KAMARY COMMONS

M.P.C.D. #08-06-002

MASTER PLANNED COMMUNITY DISTRICT PLAN

Re: **Kamary Commons**

P9
SHEET
1 OF 1

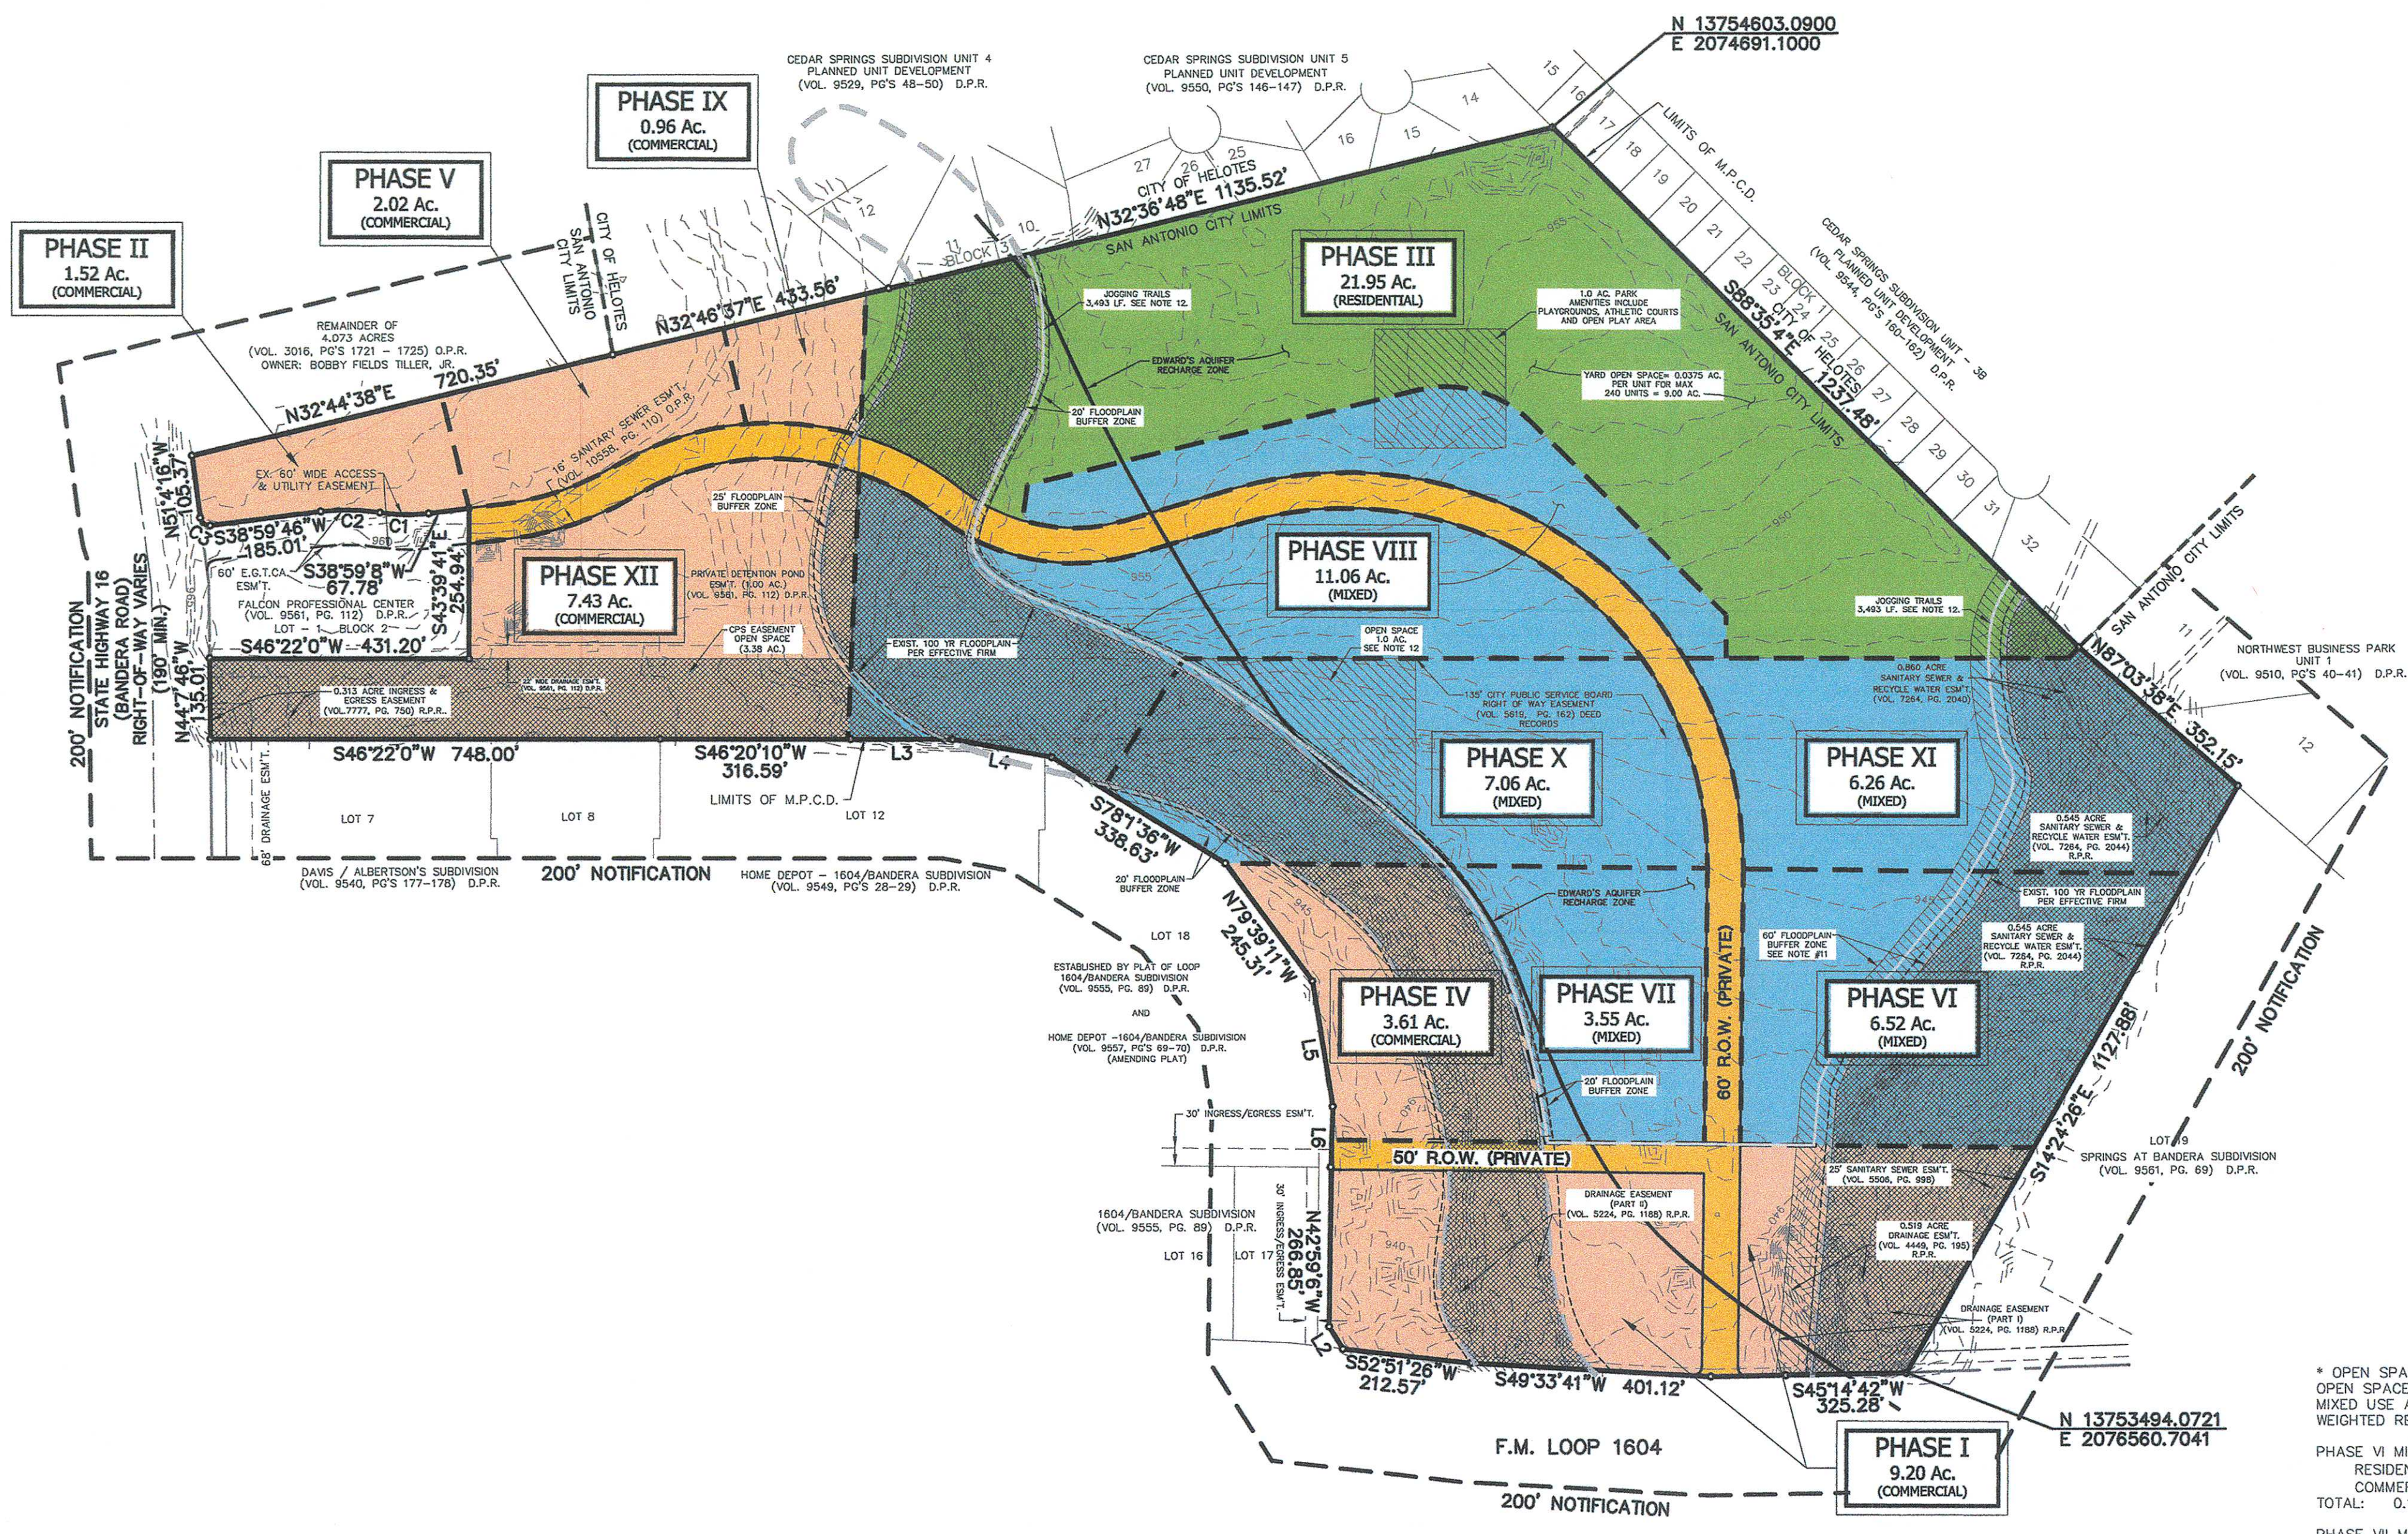
This project is subject to the 2006 Tree Preservation Ordinance. There is additional canopy that will need to be delineated for future submittals. It appears that there has been prior site work done without a permit. This issue will need to be addressed.

The Texas Sites Atlas indicates that no archaeological sites have been previously identified within the above referenced property. However, archaeological site 41BX69 is located just outside the boundaries of the property and due to the presence of French Creek, the property may contain sites, some of which may be significant. Thus, before any work that might affect any sites is begun we recommend that a qualified professional conduct an archaeological investigation of the property. The investigation should be performed according to Archeological Survey Standards for Texas, and

1. Prior to the release of any building permits the owner/operator of any Category 2 property shall submit an Aquifer Protection Plan to the Resource Protection Division of the San Antonio Water System.

2. Prior to the release of any building permits, the following shall be submitted to the SAWS Aquifer Protection and Evaluation Section of the Resource Protection Division:

This is a general review of a conceptual plan not an in-depth review of internal and external traffic flow, or streets and drainage plans. The internal street network shall be planned in order to provide safe and efficient movement of traffic to and from, within and past, the proposed development, while minimizing the impact to non-site trips. All technical requirements of the Unified Development Code will be complied with at the time of platting or permitting.
